Project	IEEE 802.16 Broadband Wireless Access Working Group < http://ieee802.org/16 >	
Title	Preamble Structure for STC/MIMO Zone	
Date Submitted	2004-08-17	
Source(s)	Jing Wang Sean Cai Jason Hou Jun Han Dazi Feng	jwang@ztesandiego.com scai@ztesandiego.com jhou@ztesandiego.com jhan@ztesandiego.com dfeng@ztesandiego.com
	ZTE San Diego Inc. 10105 Pacific Heights Blvd. San Diego, CA 92121 USA	Voice: 858-554-0387 Fax: 858-554-0894
Re:	Propose STC/MIMO Zone preamble sequences	
Abstract	Proposing STC/MIMO preamble sequences for STC/MIMO for in IEEE P802.16e/D5-2004	
Purpose	To improve the performance of STC/MIMO.	
Notice	This document has been prepared to assist IEEE 802.16. It is offered as a basis for discussion and is not binding on the contributing individual(s) or organization(s). The material in this document is subject to change in form and content after further study. The contributor(s) reserve(s) the right to add, amend or withdraw material contained herein.

Preamble Structure for STC/MIMO Zone

Figure 7. STC/MIMO Zone preamble allocation in FUSC for 2 antennas

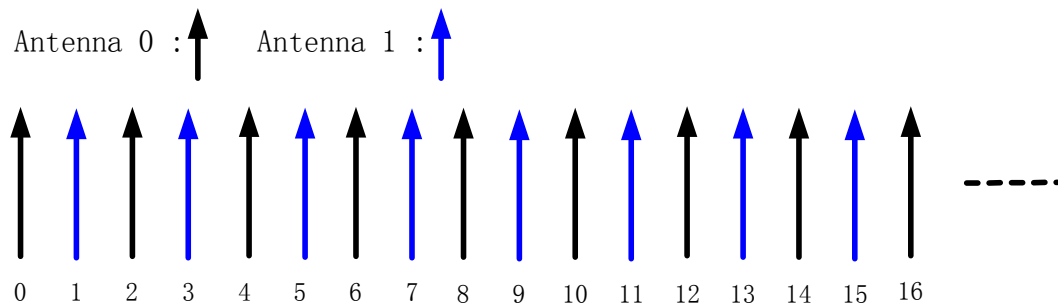
Over the entire N_{used} subcarriers (excluding DC), the subcarriers are evenly distributed into subsets of subcarriers with equal spacing; each subset is assigned for an antenna. For two, three, and four antennas, the patterns are shown in Figure 7, Figure 8, and Figure 9 respectively.

Figure 10. STC/MIMO Zone preamble allocation in FUSC (2-symbol, 3 antennas)

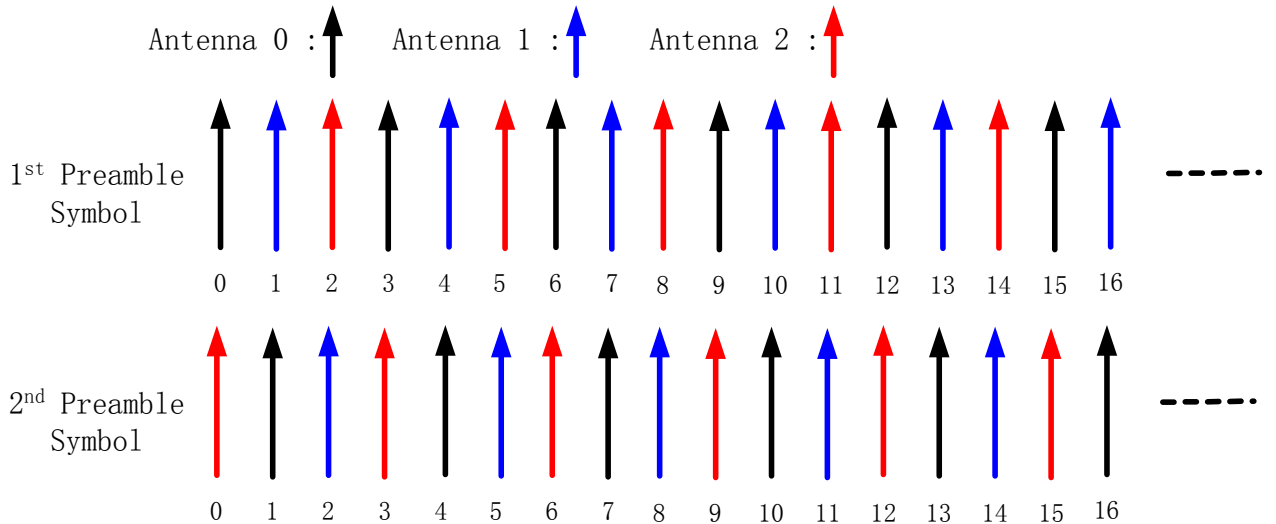
For more than two antennas, each symbol is transmitted by a set of 2 or 3 antennas. For example, the preamble allocation for 3 and 4 antennas is shown in Figure 10 and Figure 11 respectively.

Figure 12. Preamble allocation of each physical cluster (2-antenna case)

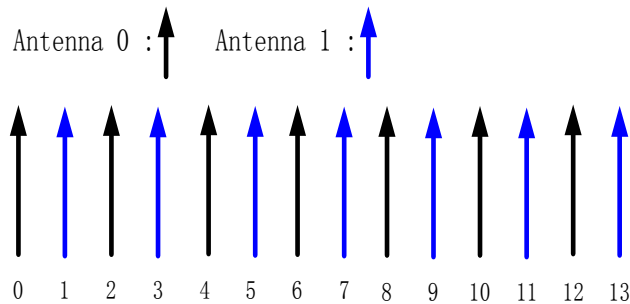
The 14 subcarriers in each cluster are evenly distributed into subsets of subcarriers with equal spacing; each subset is assigned for an antenna. Figure 12, Figure 13, and Figure 14 show the preamble allocation for 2, 3 and 4 antennas.

Figure 15. Preamble allocation of each physical cluster in PUSC (2-symbol, 3 antennas)

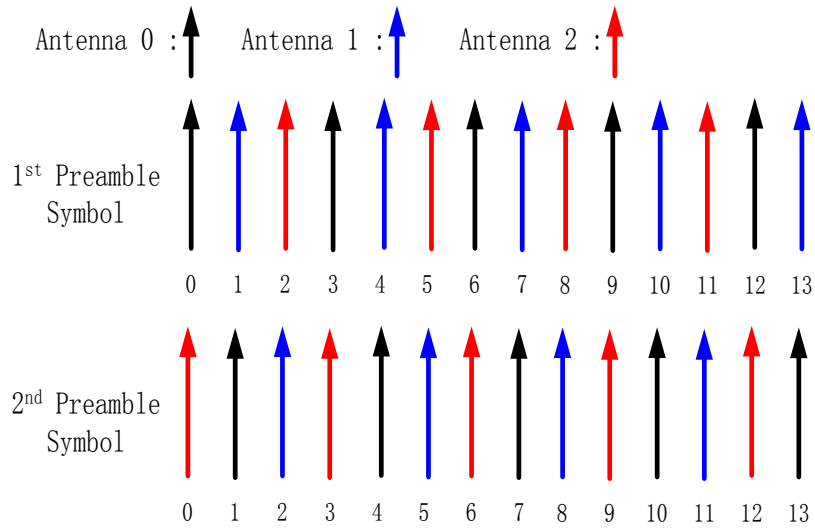
Two symbols are transmitted before the STC/MIMO Zone within each cluster. For more than two antennas, each symbol is transmitted by a set of 2 or 3 antennas. For example, the preamble allocation of each cluster for 3 and 4 antennas is shown in Figure 15 and Figure 16 respectively.
